SOUTH END LANDMARKS DISTRICT COMMISSION PRESENTATION | 12.7.2021

10 UNION PARK

CURRENT PROPOSAL

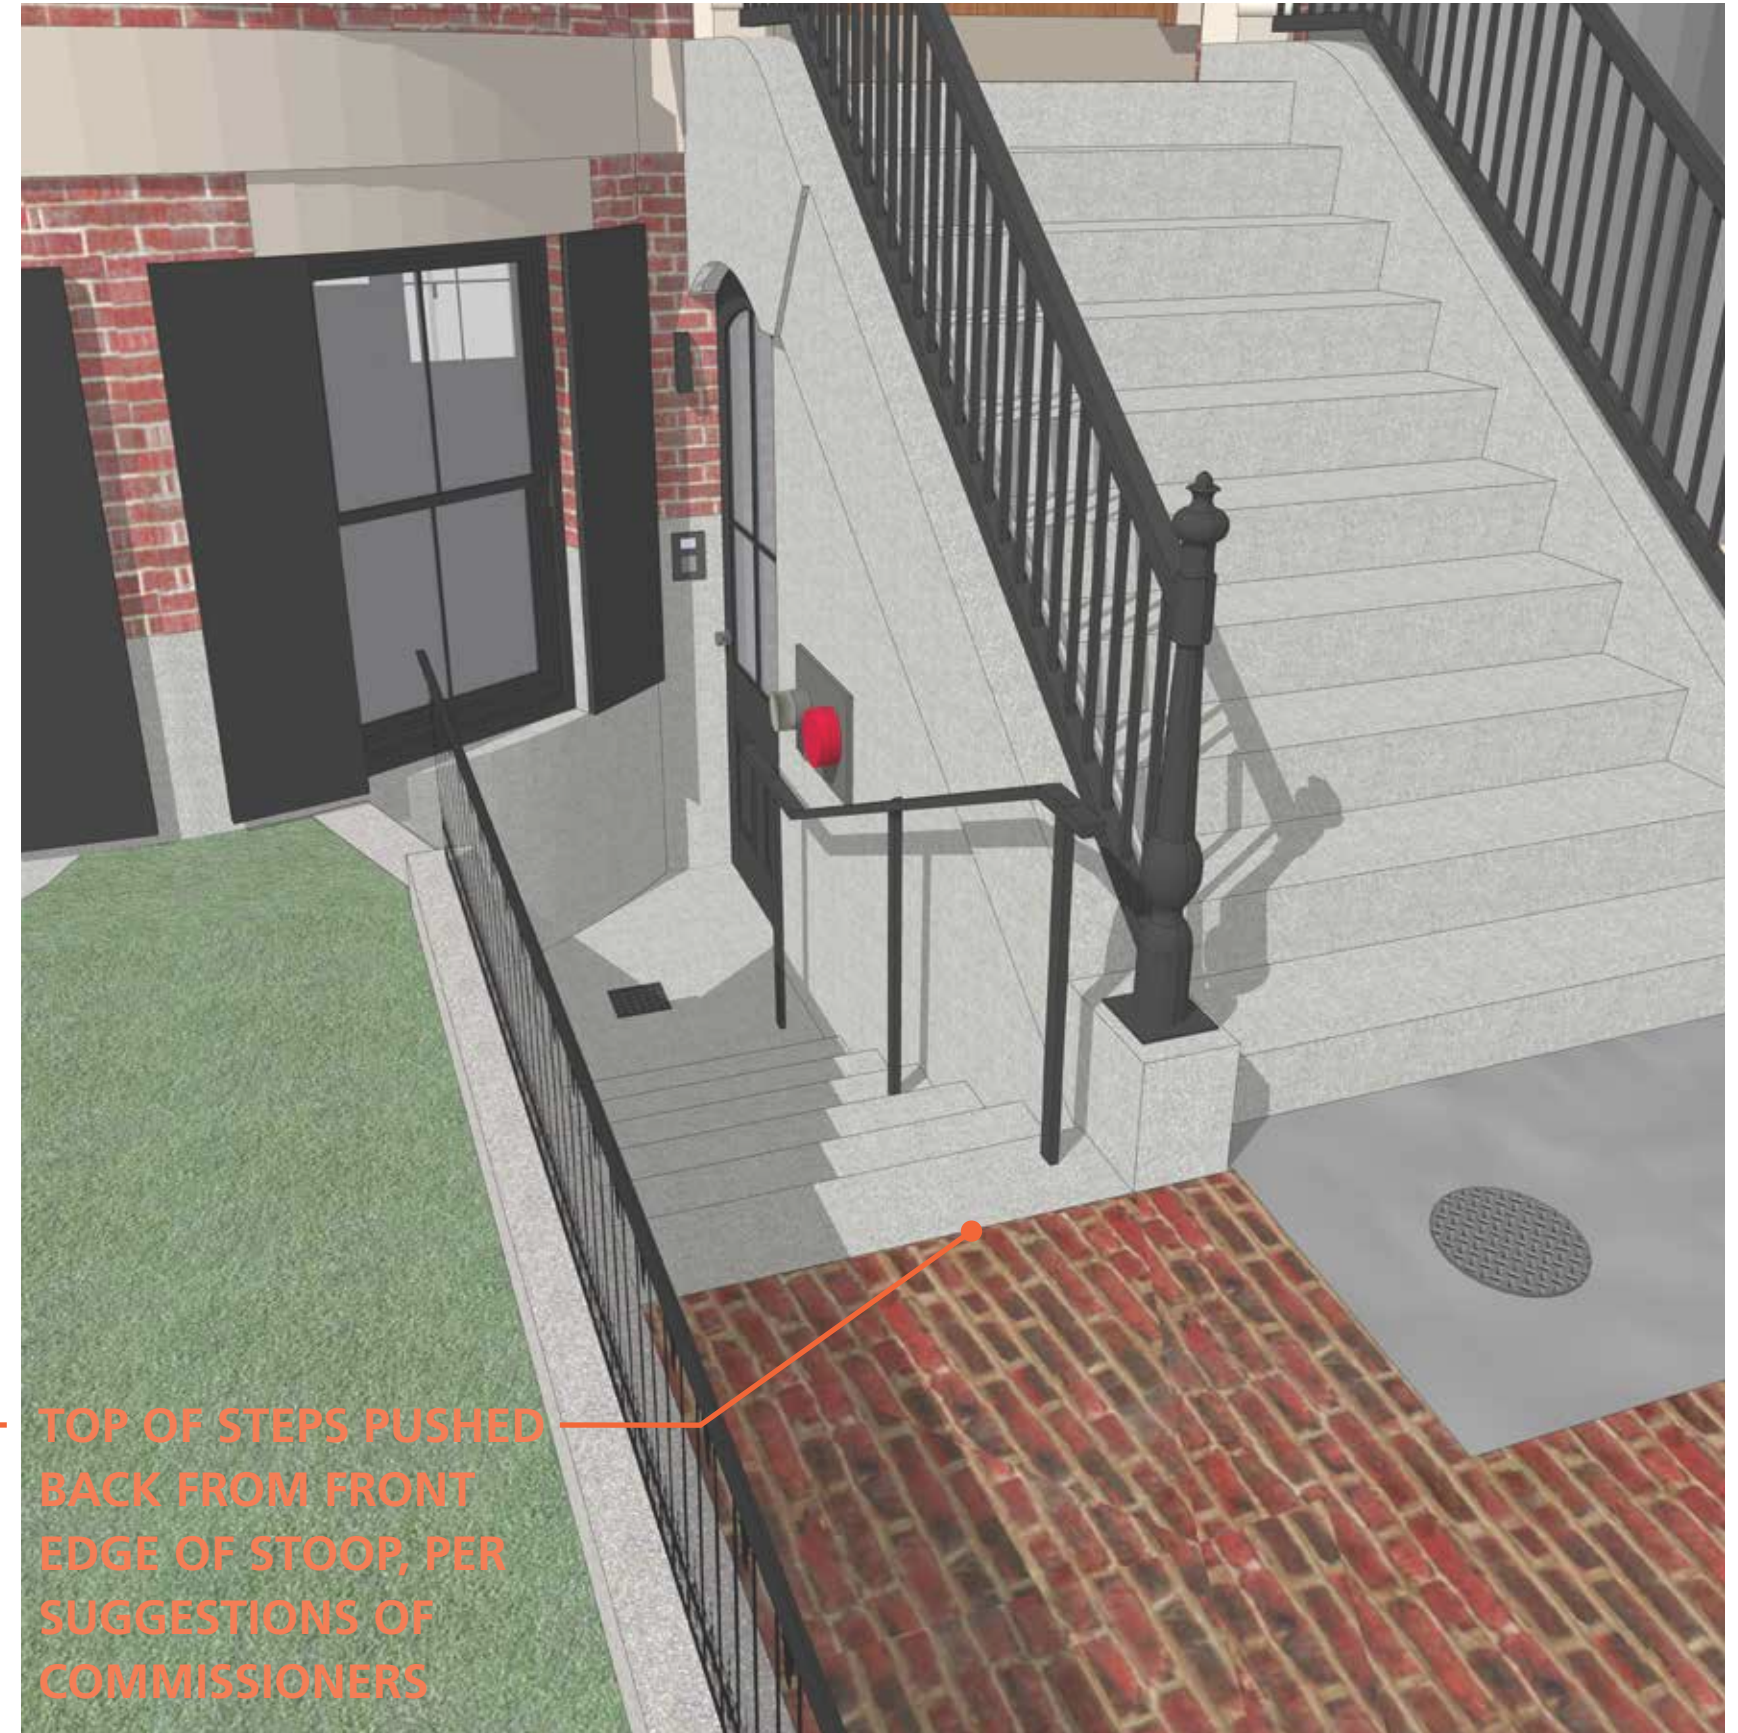
TOP OF STEPS PUSHED
BACK FROM FRONT
EDGE OF STOOP, PER
SUGGESTIONS OF
COMMISSIONERS

PROPOSED EXPANDED DORMER

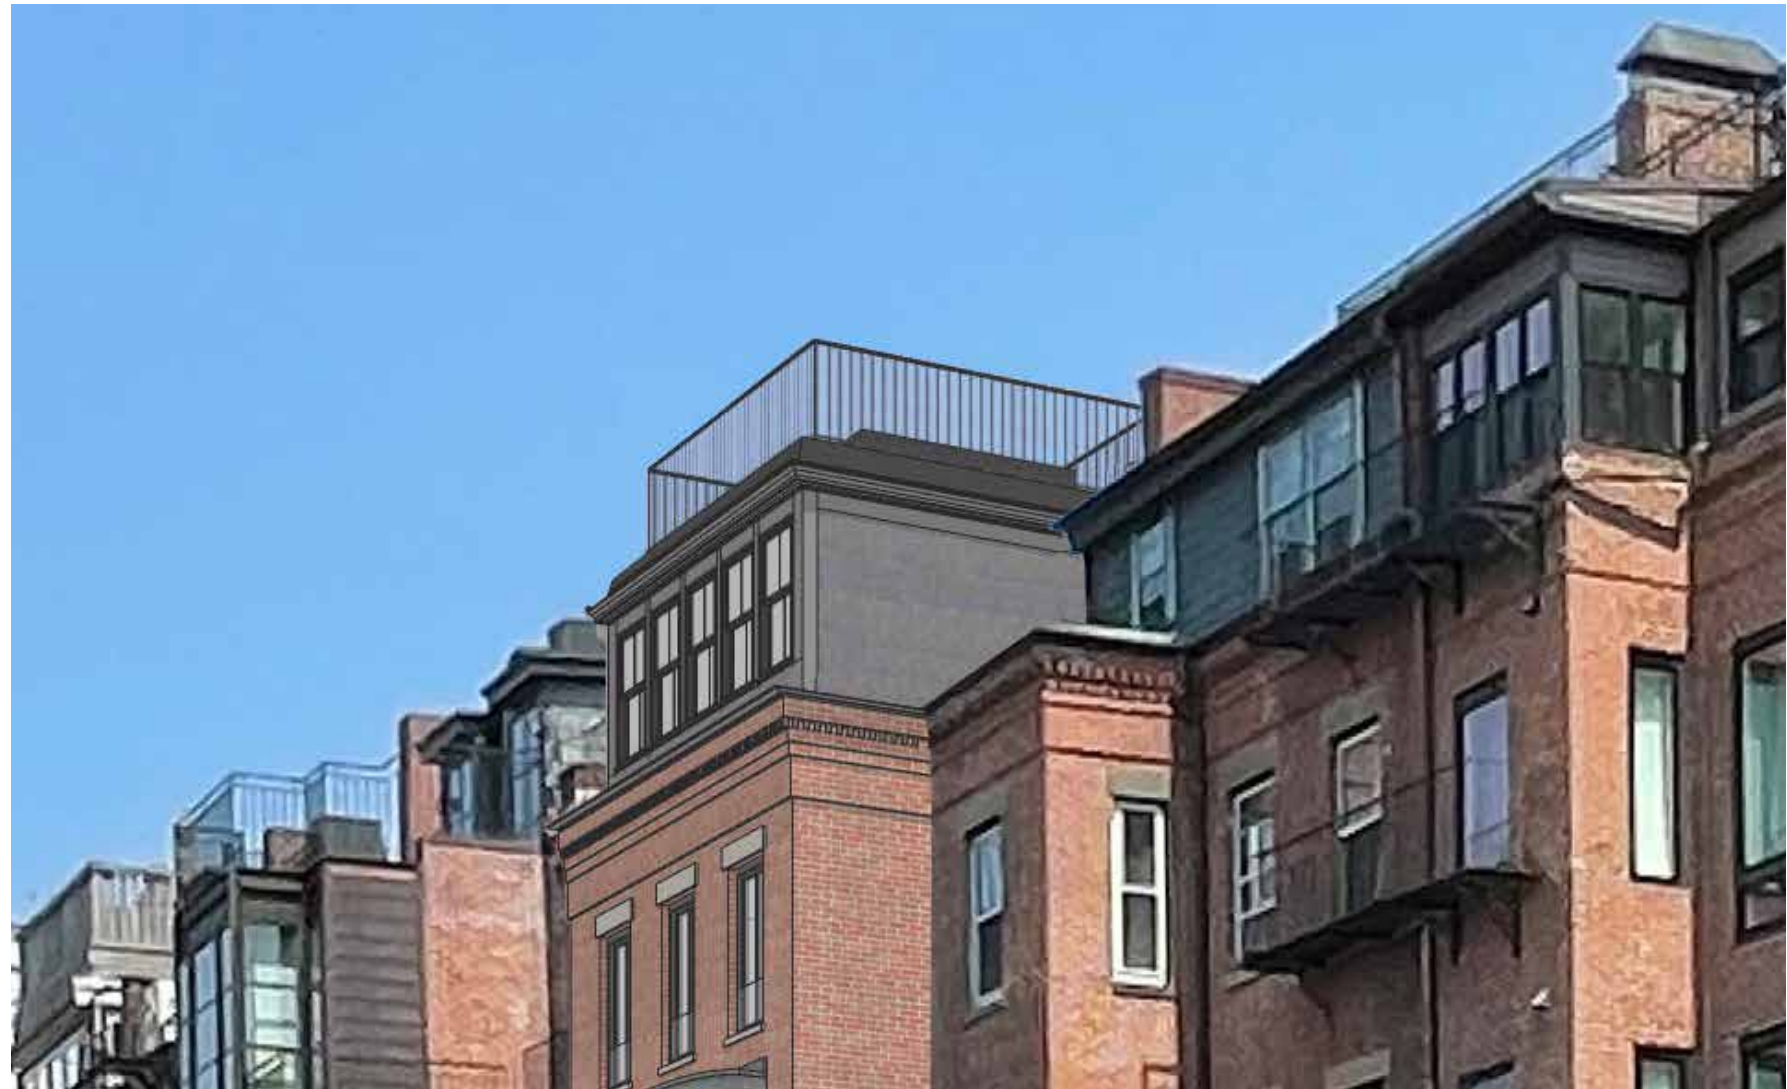
- FEEDBACK FROM COMMISSIONERS ON 9/27/21:**
- ROOF DECK NOT ALLOWED
 - MODIFY SIZE AND CONFIGURATION OF EXPANDED DORMER

- EXPANDED DORMER SET BACK AND REDESIGNED TO ALIGN WITH AND REPLICATE EXISTING HISTORIC DORMER
- ROOF DECK ELIMINATED
- HISTORICALLY APPROPRIATE METAL RAILING AT 5TH FLOOR DECK, ABOVE BRICK CORNICE

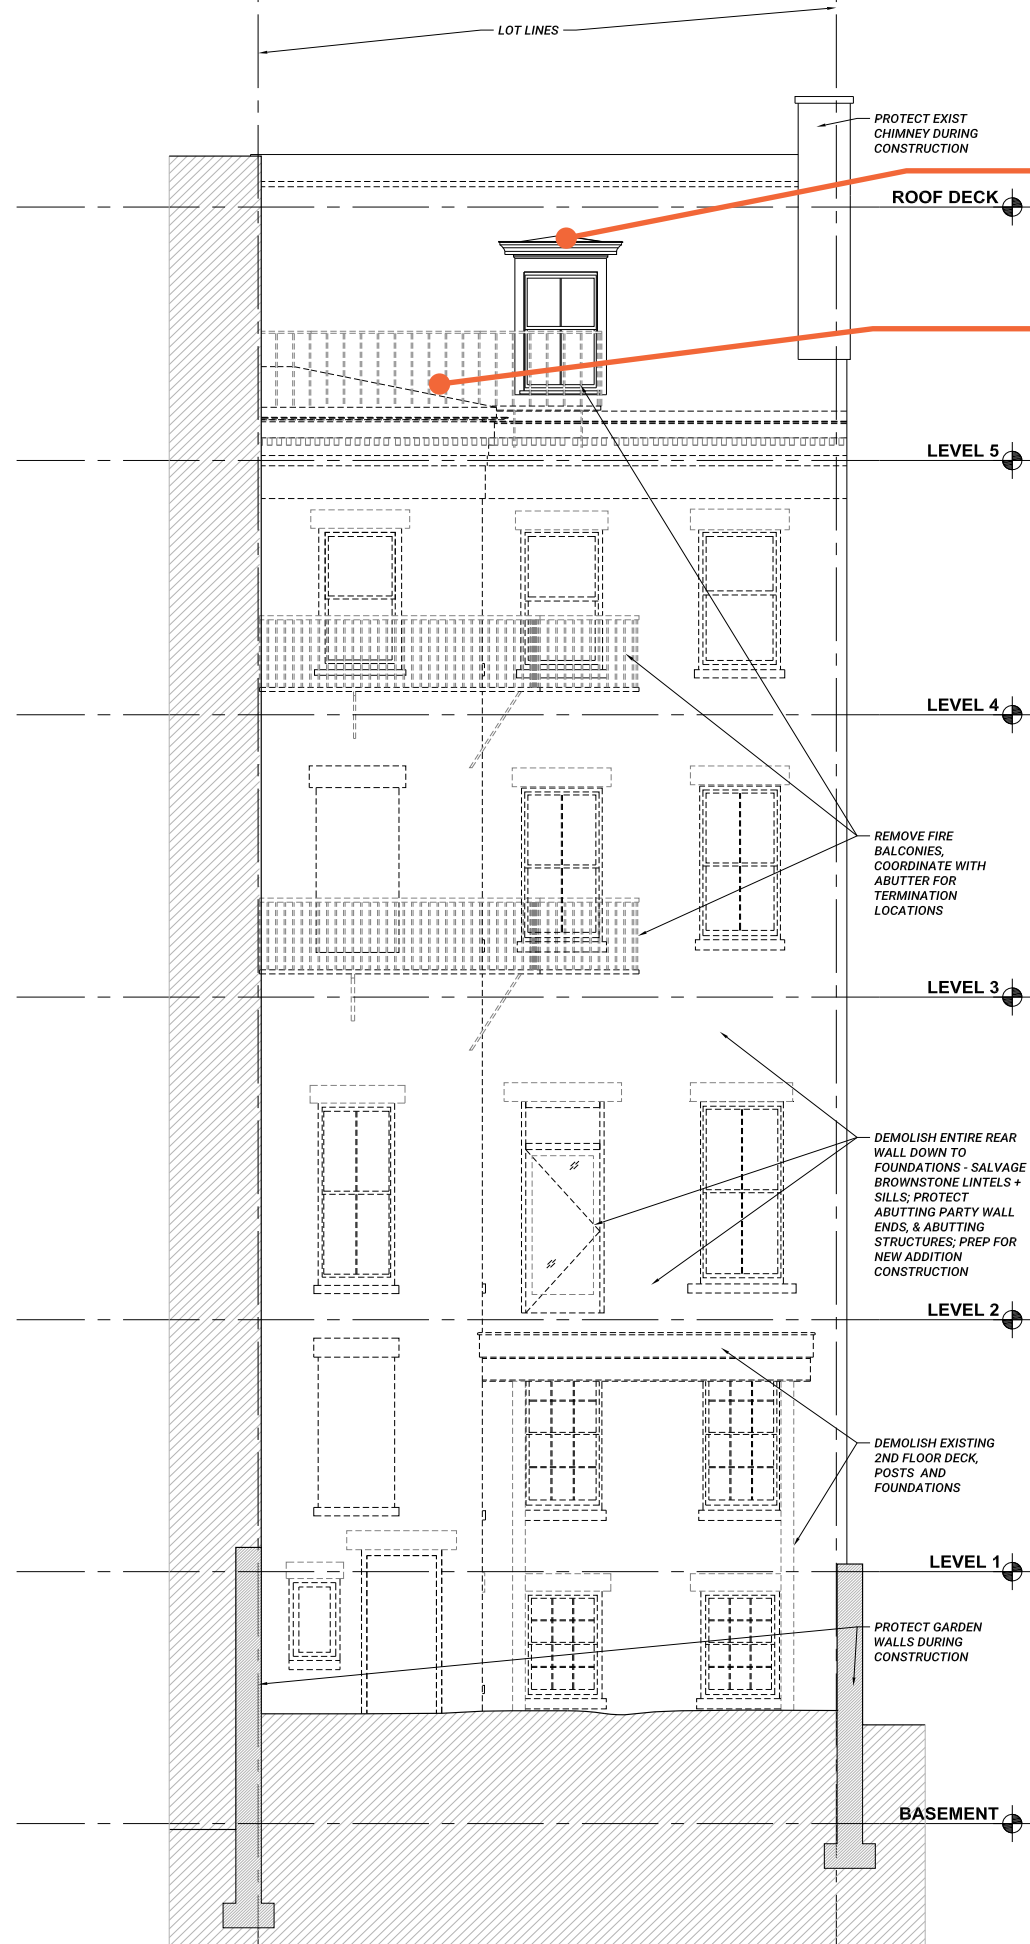
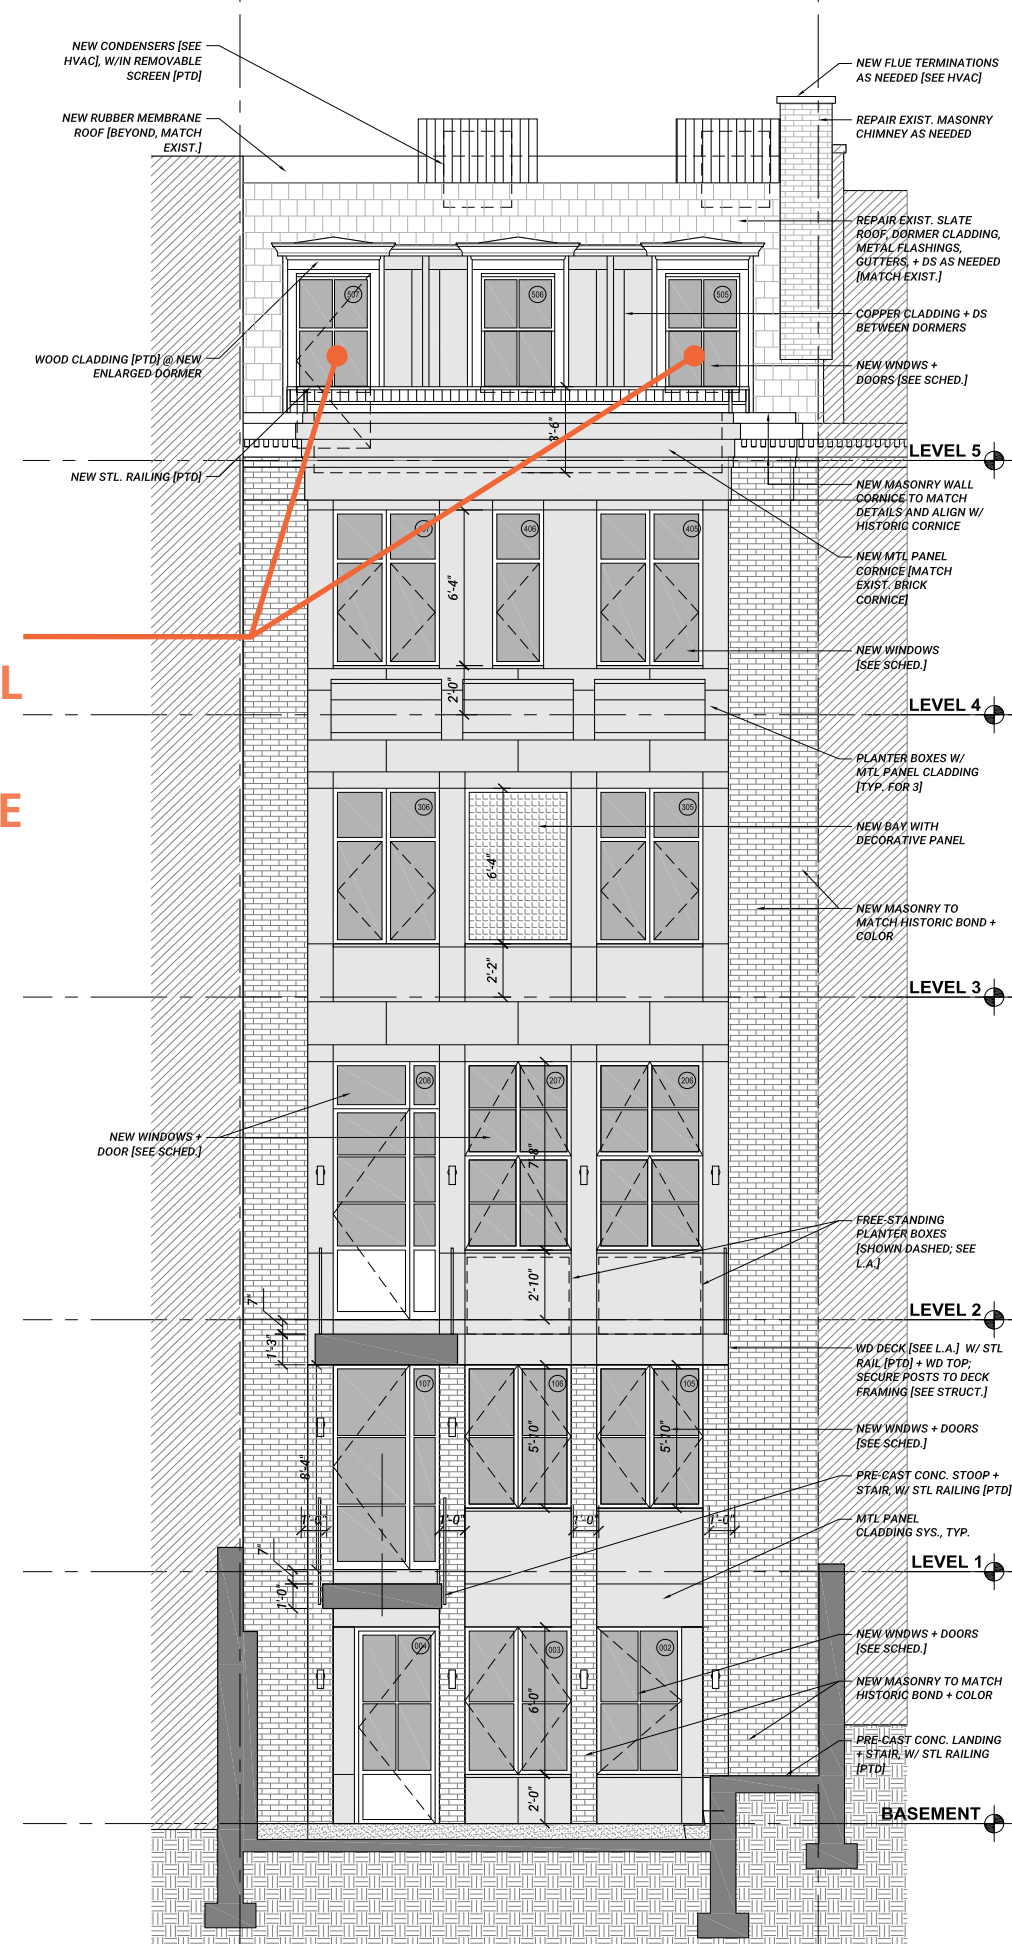
EXISTING FIRE BALCONIES TO BE REMOVED

EXPANDED DORMER REPLICATES ORIGINAL DORMER DESIGN AT EACH SIDE TO CREATE HISTORICALLY APPROPRIATE CONFIGURATION
